Contract #: 04-0120F4
 Cty: SF/ALA Rte: 80 PM: 13.2/13.9
 File #: 69.25B

QUALITY ASSURANCE -- NON-CONFORMANCE REPORT

Report No: NCR-000193

Reference Description: Diaphragm Installation Unapproved Repairs

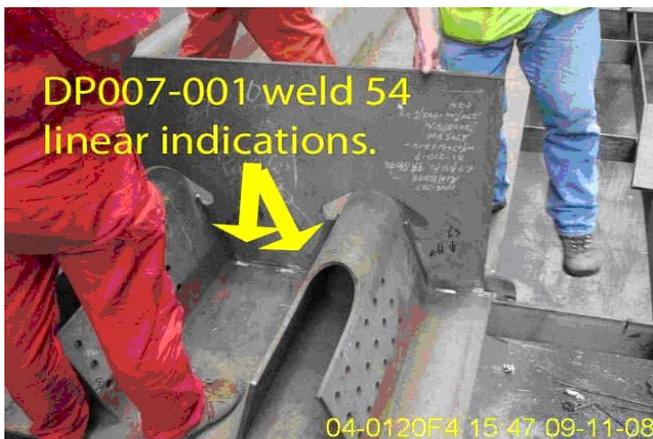
The Contractor has not complied with the written order of the Engineer to suspend work. The Contractor has welded diaphragm plates to deck panel DP007-001. Additionally, the Contractor performed unapproved repairs to cracks and base metal on the non-compliant welds. This was observed on weld joint # -0054 of deck panel DP007-001.

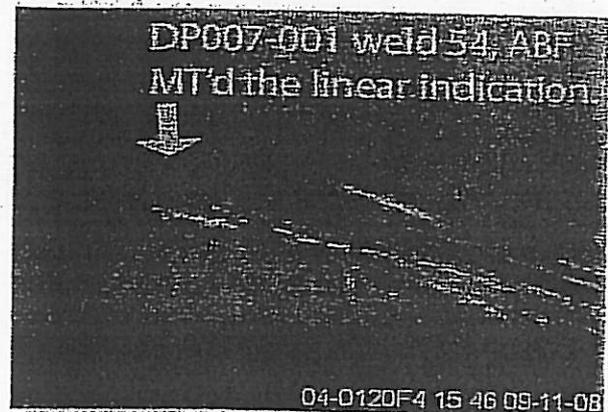
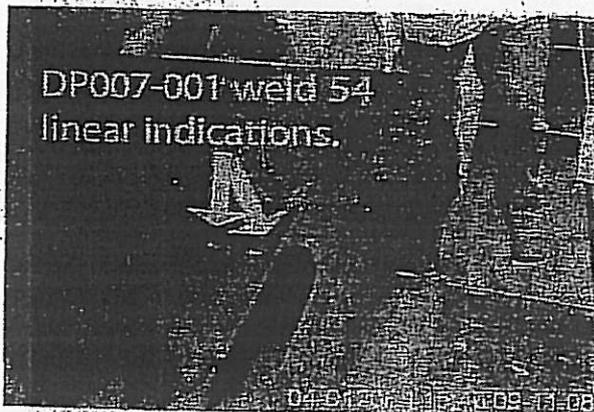
The Contractor has not complied with the written order of the Engineer to suspend work. The Contractor has welded diaphragm plates to deck panel DP007-001. Additionally, the Contractor performed unapproved repairs to cracks and base metal on the non-compliant welds. This was observed on weld joint # -0054 of deck panel DP007-001.

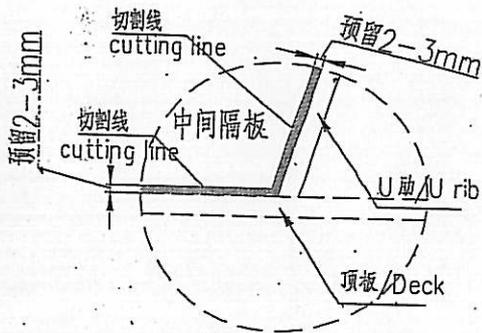
- 1、由于材料经过钢板仓库报验合格后，才进入下道工序施工，母材有问题下道工序无法确认。
The base metal was checked as ACC by steel plate storehouse, and then it was sent to the workshop for fabrication, when we cannot confirm whether there was any problem.

- Remove the all diaphragm by gouging or oxygen cutting according to the drawing 1 from the deck after grind the tack welding between diaphragm and diaphragm and clean the leave part by means of grinding and deal with according to the below steps.

- Inspect base metal by use of UT in range of 1m to ensure the defects area, and random inspection the other area according to practice condition to ensure whether it is defects or not, if it is no defects, repair according to the following process, if it finds some defects, it shall stop repairing to notify technology department.

- Prepare excavation with relevant WPS. c. 100% VT and MT to verify repair area is free of all defects.
 - Preheat and weld according to the relevant WPS.

- Grind the weld flush with base metal after welding.
 - Perform NDT(VT MT UT) inspection of the repaired area.
- Assemble the diaphragm again according to the shop drawing.
